PUBLIC HEARING MEMORANDUM

SUBJECT: **Petition #448-22**, petition for SPECIAL PERMIT/SITE PLAN APPROVAL to allow a three-story structure with 36 feet in height; to allow an FAR of 1.48; to vertically extend a nonconforming front setback; to waive 4 parking stalls and to allow assigned parking at 1 Jackson Street, Ward 6, Newton, on land known as Section 65 Block 10 Lot 19, containing approximately 12,512 sq. ft. of land in a district zoned BUSINESS 1. Ref: 7.3.3, 7.4, 4.1.2.B.3, 4.1.3, 7.8.2.C.2, 5.1.4, 5.1.13, 5.1.3.E of Chapter 30 of the City of Newton Rev Zoning Ord, 2017.

1 Jackson Street

Proposed Site Plan:

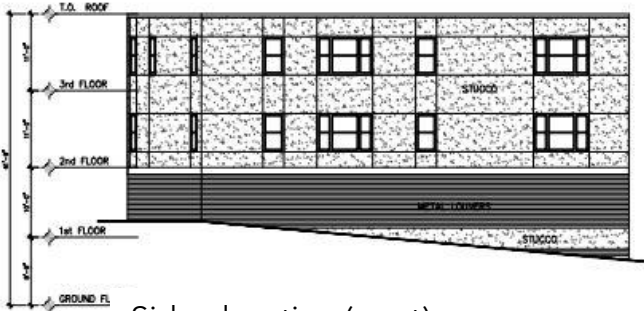
The structure will consist of four residential units on the upper two stories. Along the frontage of the site on the south elevation facing Jackson Street is the entrance for cars to the lower-level parking, with no pedestrian access. While the structure is considered a three-story structure due to the grade of the site, the building will present as four stories from Jackson Street. The architectural plans showed the south

(front) elevation as having a pedestrian door, however the petitioner stated that was a drawing error from an earlier iteration of the project. It is anticipated the petitioner will provide revised drawings.

Proposed Elevations

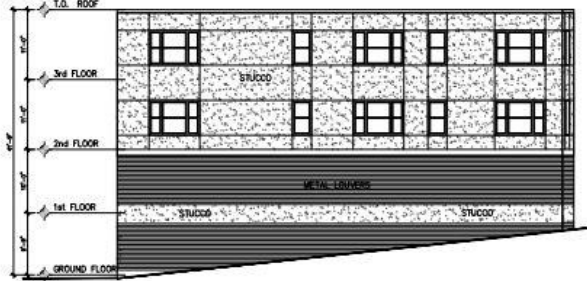
The Planning Department is unconcerned with the proposed extension of the nonconforming front setback and increase in FAR. The addition will be located within the footprint of the existing building, and at a total of three stories, the building will not be out of scale with other structures in the area. The project is close to neighborhood amenities and a mix of different uses commercial and multi-family

The Planning Department acknowledges that because the applicant is retaining the existing parking garage, this design inherently has a car-centric focus. However, staff suggest incorporating elements to make the design more welcoming and pedestrian oriented than what is currently proposed. This could include reconfiguring the design to enable resident access from the front of the building, plantings on the frontage on Jackson Street, etc. Staff suggest the applicant present the proposed plan to the Urban Design Commission for review on this matter.
